CORRECTIONS/AMENDMENTS TO THE DRAWINGS

REMARKS

The Examiner objected to the drawings due to non-consecutive numbering and some elements having no numbering. By this Amendment, corrected drawing sheets in the form of Replacement Sheets (as well as sheets indicating the corrections made) are submitted, which include corrected numberings, etc. The Replacement Sheets of drawings are believed to be in compliance with 37 CFR 1.121(d).

Figure 7C ~~the broad beam.~~

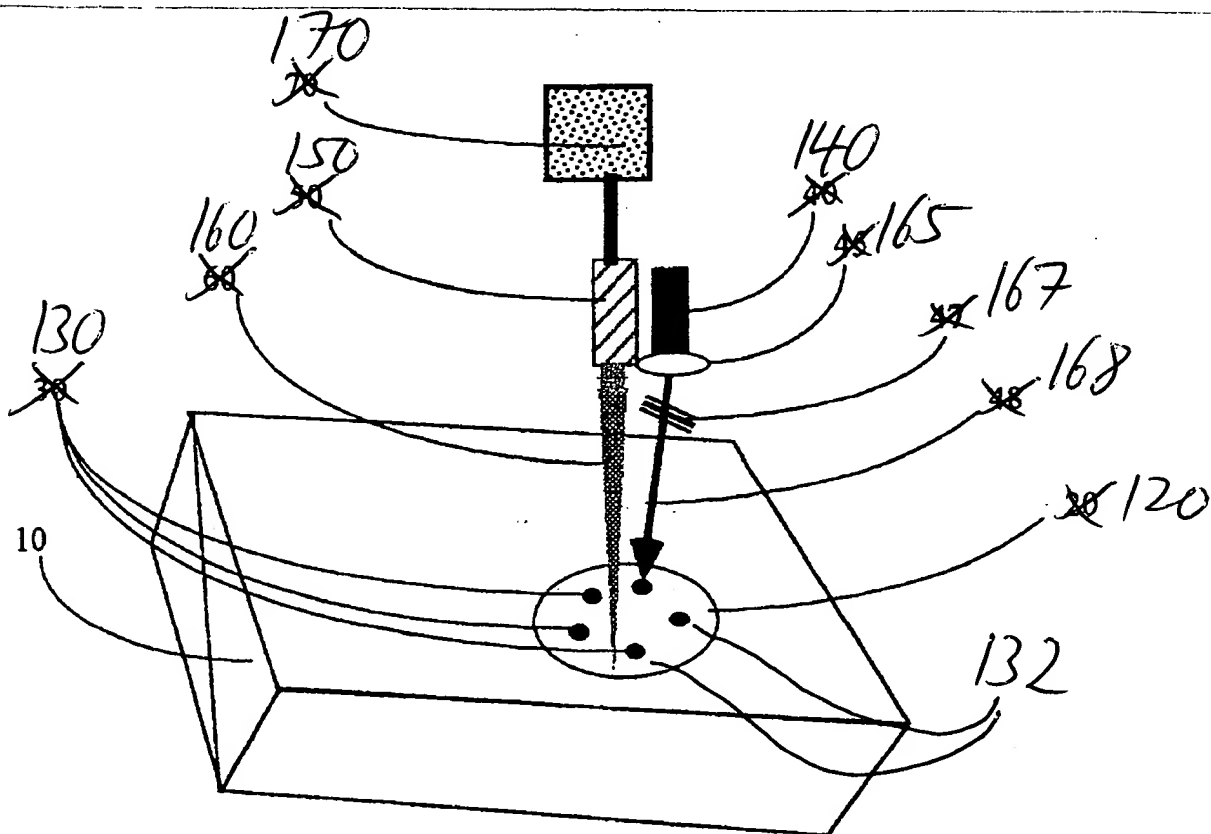
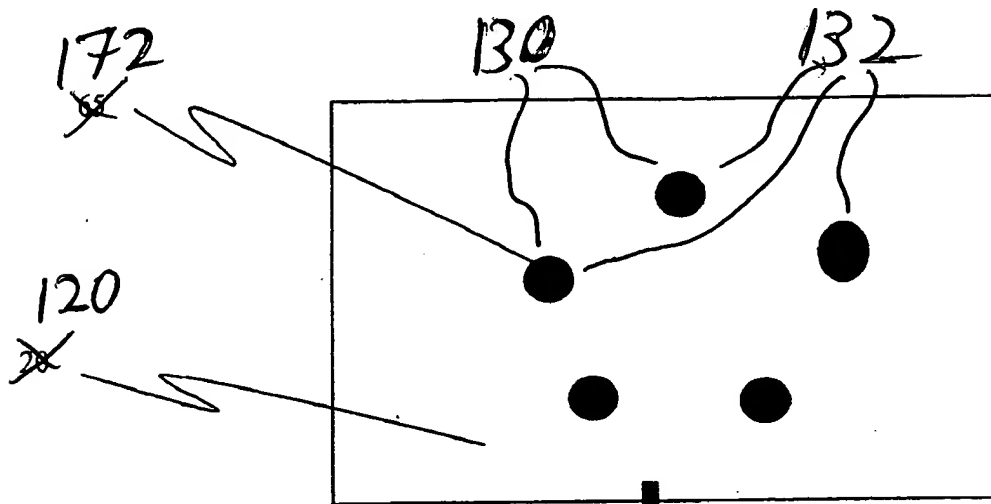
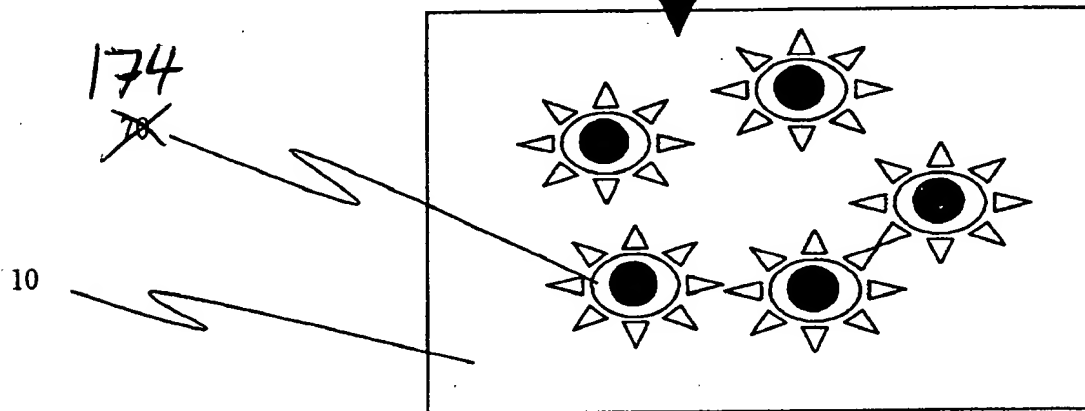
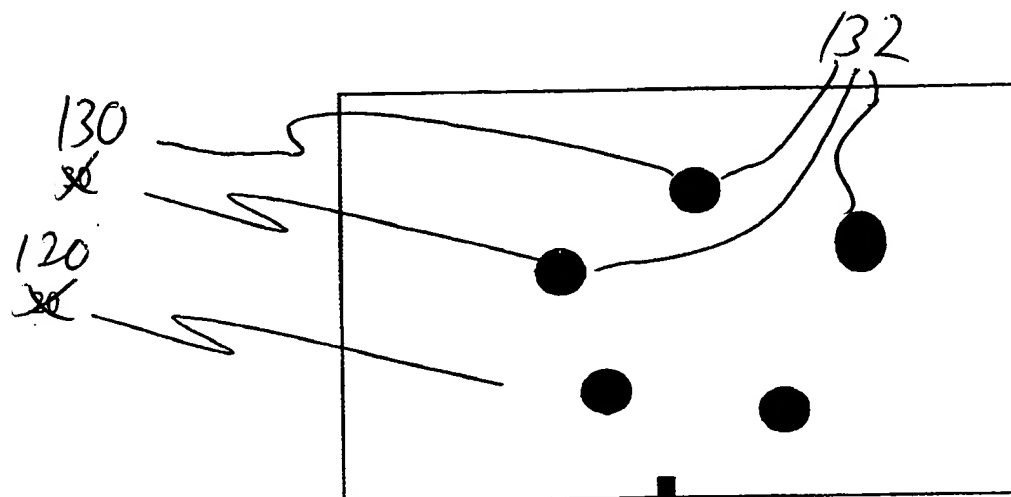
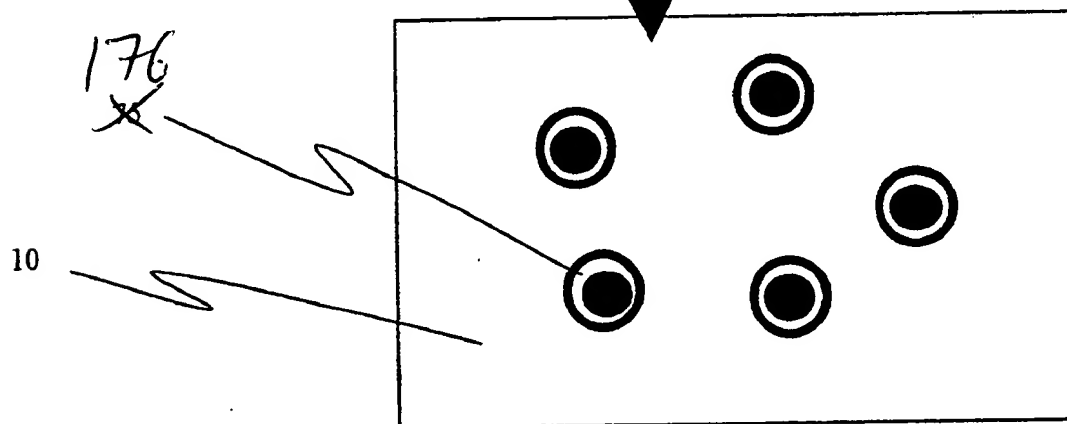
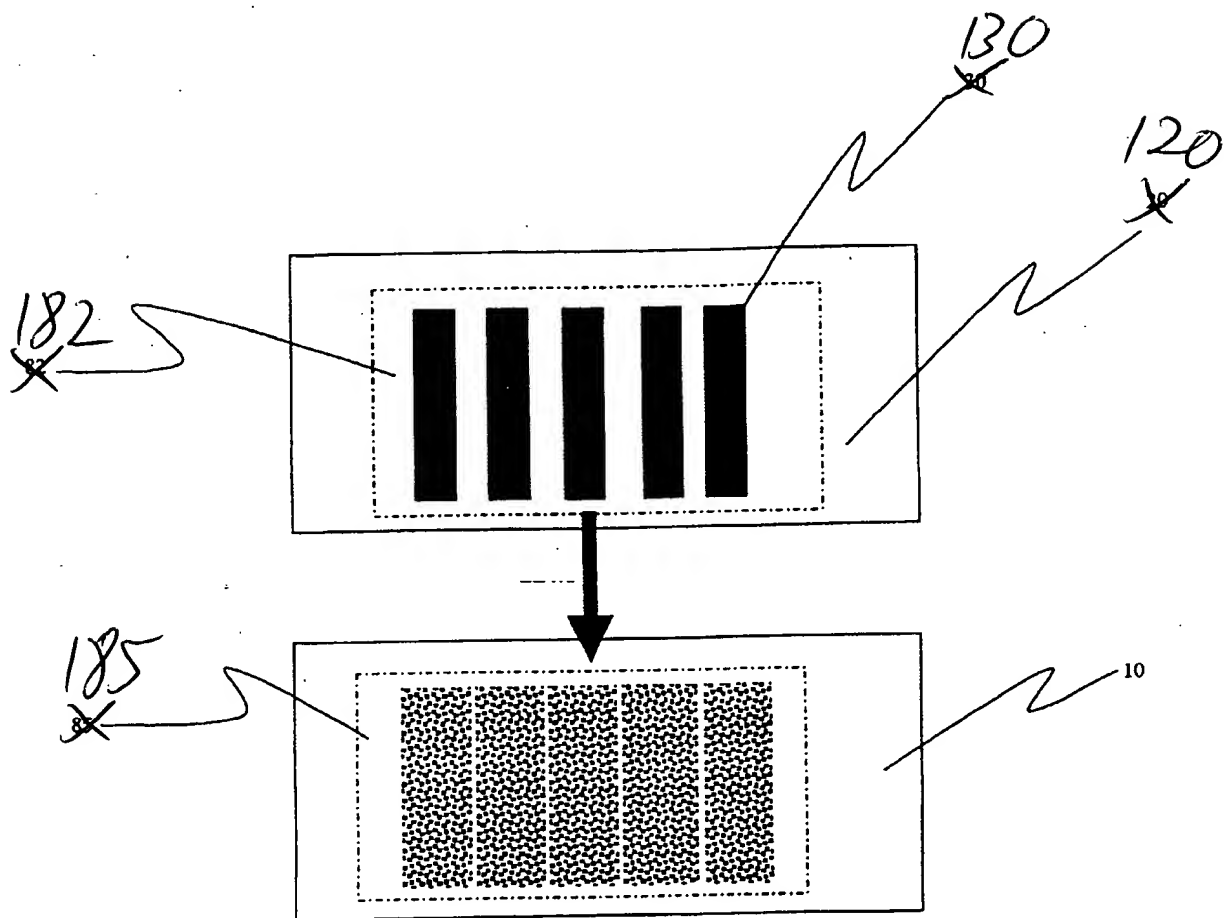
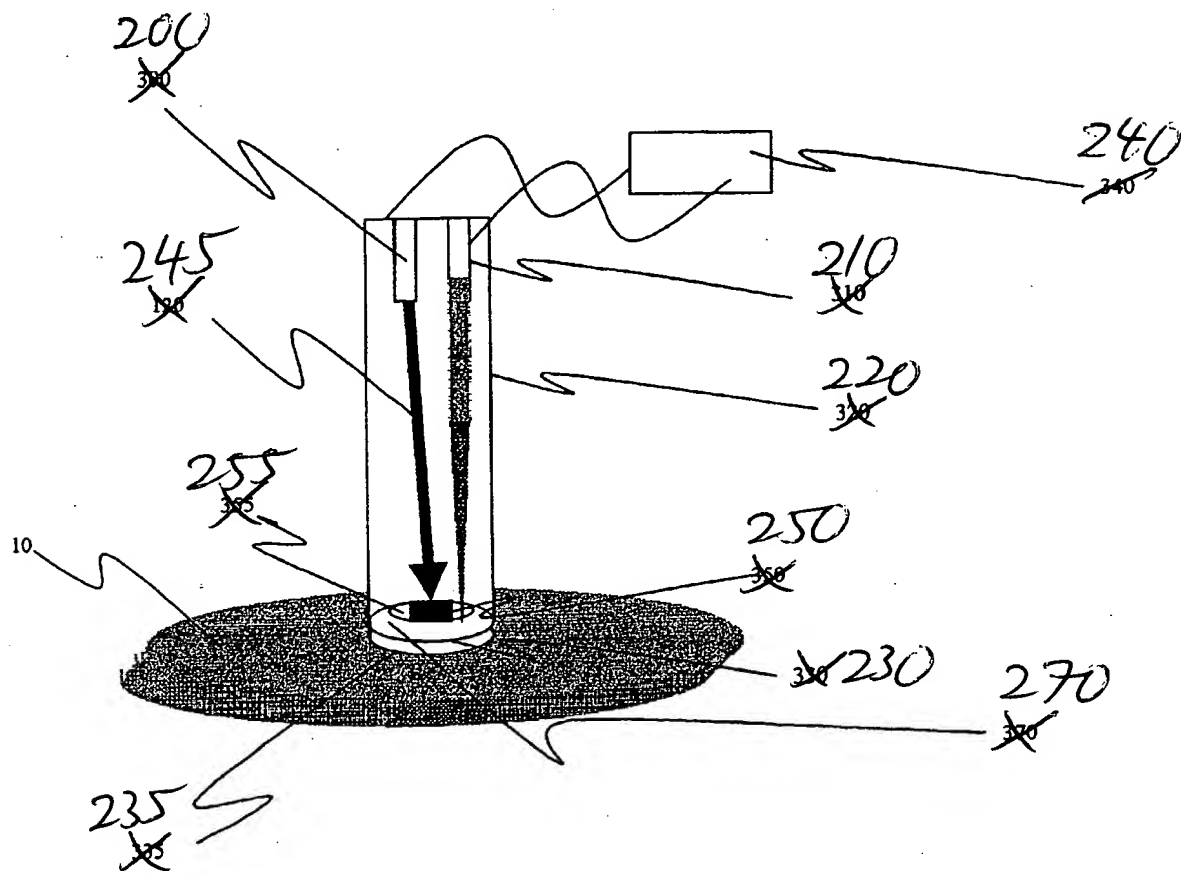
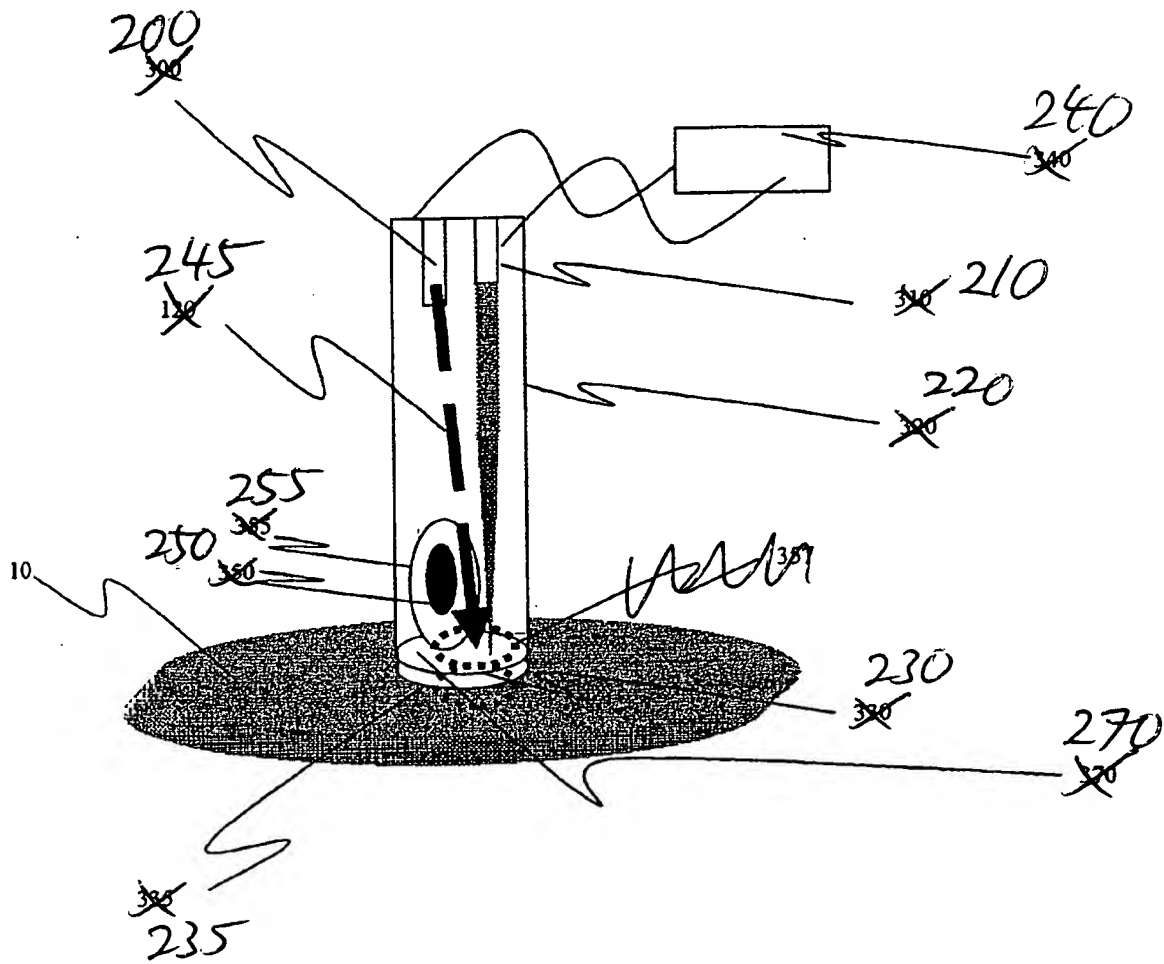
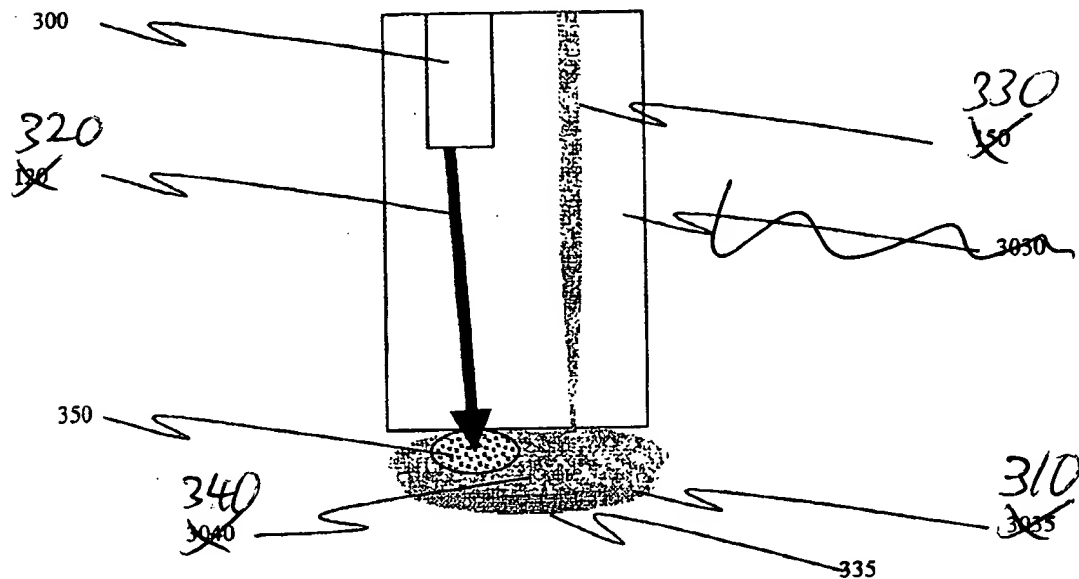
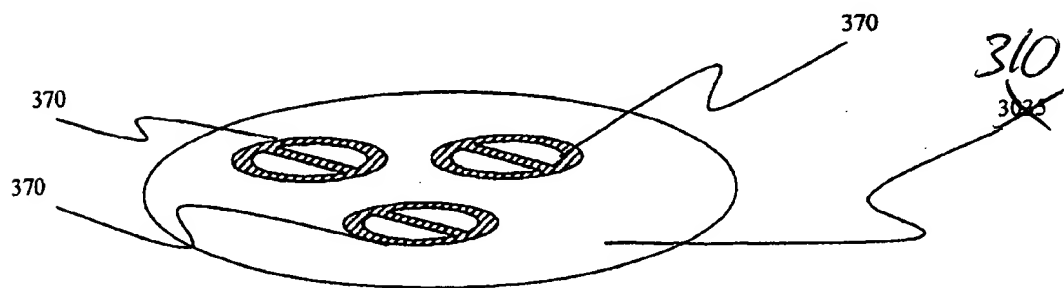
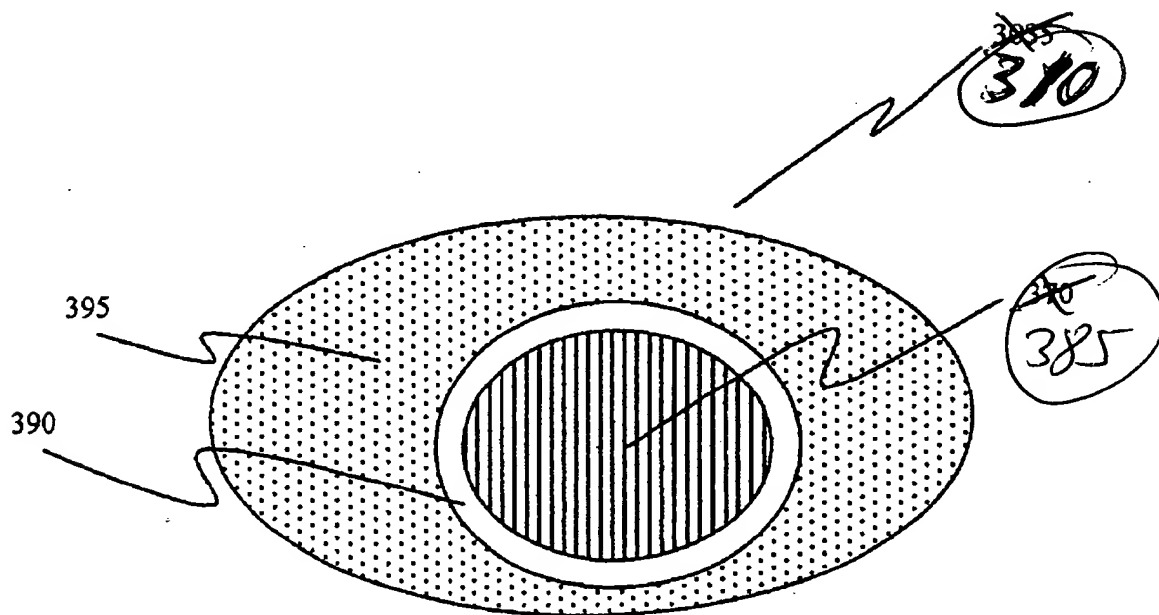
FIGS. 1A through 7F have been amended to change reference numbers for consistency with corresponding amendments to the reference numbers in the specification.
